TECHNICAL BULLETIN BETCO APPENDIX

Machine model: Genie APS
Since the serial number: 209005313
Date: 29/05/2009
Subject: Modification on the Handle Cover

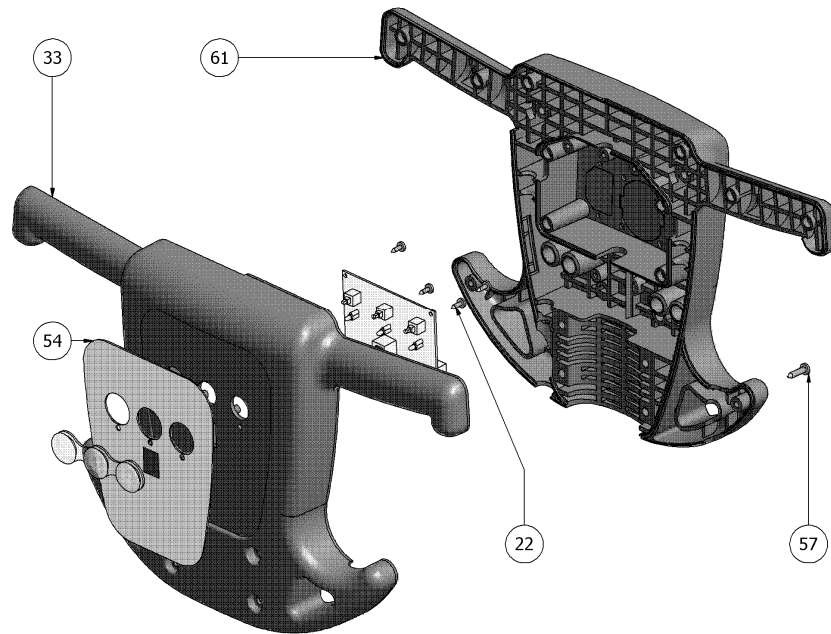
To improve the quality of the Genie APS Handle the production process changed and some modifies had been done to let the installation be easier.

REMOVE		
Q.ty	Part Number	Description
1	423062	Handle Cover
1	424457	Handle label E86191
4	415789	Screw M3x20
4	415882	Nut M3
4	409148	Washer 4x8x3 Nylon
4	409142	Washer M4
4	409077	Self locking nut M3
4	212618	Spacer d=3,5 D=8 L=6,5

ADD		
Q.ty	Part Number	Description
1	424461	Handle Cover E81781
1	428269	Label (BETCO Version)E20502
4	415866	Screw D2,9x9,5
2	408872	Scres D.3,9x16

The handle body (pos 61 code 416745 in the drawing) had not been modified but we always suggest, in case you need to replace the cover, to replace the body as well. This suggestion is to assure the compatibility in colors and mechanics.

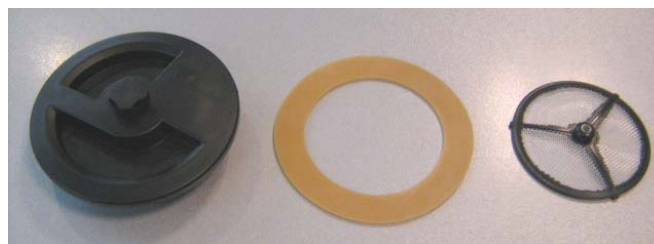
Machine: GENIE B
Since the serial number: 209003661
Date: 06/04/2009
Subject: Solution tank cap solution tank filter

To improve the performances of the solution tank cap the old model has been replaced by a new one:

RIMUOVERE	
CODE	DESCRIPTION
422005	Solution tank cap
423100	Solution tank filter

ADD	
CODE	DESCRIPTION
216412	Solution tank cap new style E81548
425742	Solution tank filter new style E88233
